Principal Objection

No. 20 Beatty Street, Balgowlah Heights

DA2024/0635

Ref: OBJ53-A2(PO) Beatty St 20

Figure 1: Rear of the proposed dwelling – long sections 01 and 02 (Source: iObject 2024)

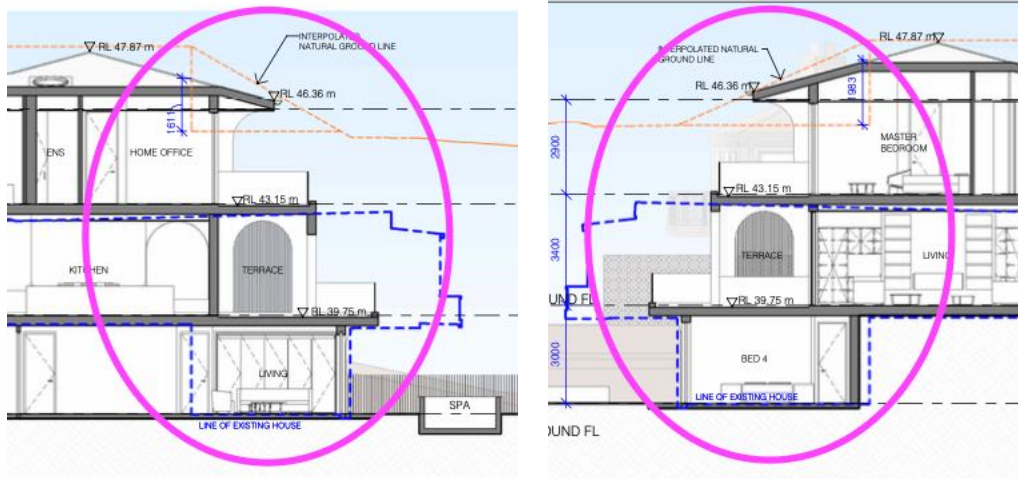
The proposal will result in a significant non-compliance with the 7.7-metre DCP wall height control, with the rear of the proposed building seeking up to 9.3 metres in wall height. The surplus wall height will result in a scale of development that would be highly visible from numerous locations, including from public and private locations. The resulting building will both negatively affect the outlook from the rear of No. 16 Beatty Street, presenting as overbearing bulk. This may cause occupants of No. 16 to feel hemmed-in when utilising rear POS's, resulting in a negative sense of enclosure.

Departure thus from the applicable wall height may also impair access to views from No. 16 looking across the subject site (from the rear of No. 16 looking north). In addition, this wall height non-compliance appears to be linked to the overshadowing impacts upon No. 16, as discussed below.

DCP 4.1.2.2 stipulates buildings must not exceed two (2) storeys, which applies to the subject site. The proposed new rear section is equivalent to three-storeys, in contravention of this storey limit. unnecessarily causing excessive building scale. End of dwelling 3 storeys, as dining room not considered basement, since above EGL

- A. **Proposed Solution:** That a revised design be requested, reducing the maximum wall height and storey height to comply with DCP controls.
